July 30, 2010

**Re: Storm Water Inspection at Storm Sewer and Water Main Construction for
Olde Pickerington / Fairfield County.
Permit Number: 4GC03039*AG**

Figure 1: Insufficient controls around storm water inlet

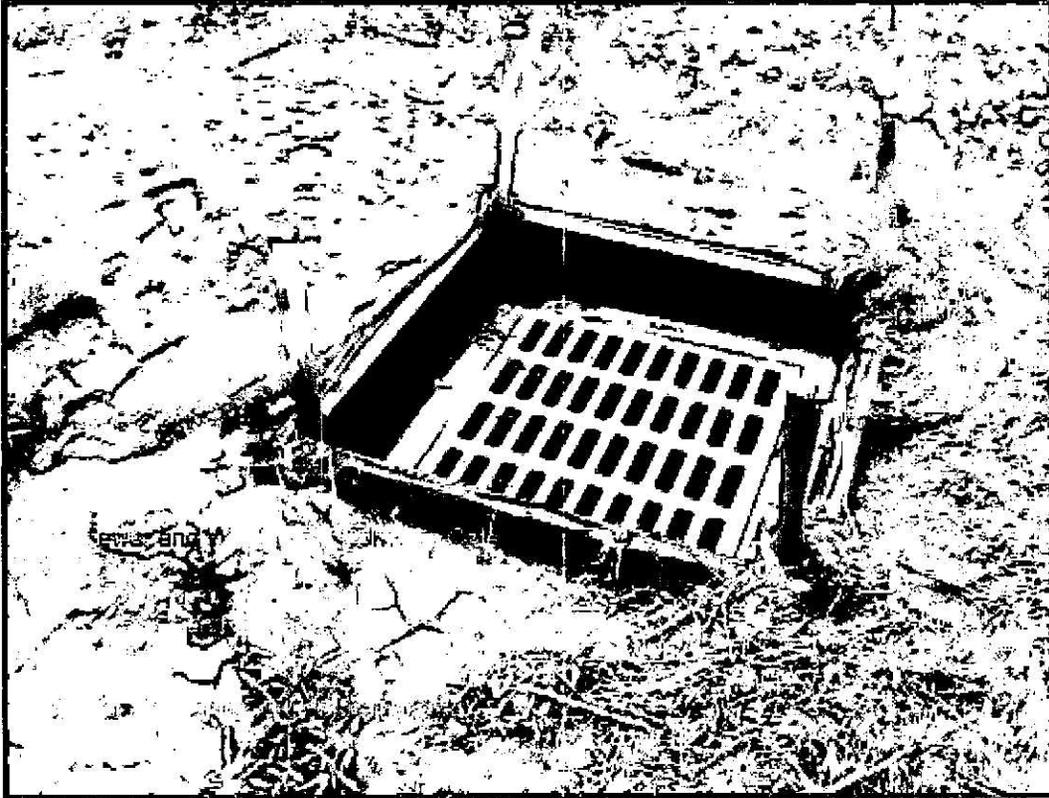
- During the inspection our staff took notice of the sediment and erosion controls for the storm water inlets. These controls lack sufficient height to insure the encroaching sediment does not spill into the storm water inlets (Figure 1). Please replace these controls with measures of greater height to avoid sediment discharges to waters of the state.
- Vegetation must be established sufficient to control erosion which is measured by a minimum vegetative density of 70%.
- The General Storm Water Permit requires specific post construction water quality treatment for all sites. Guidance regarding the post construction mandates can be found at:
<http://www.epa.state.oh.us/dsw/storm/CGPPCQA.aspx>. Please submit to my attention (email preferred at harry.kallipolitis@epa.state.oh.us) which
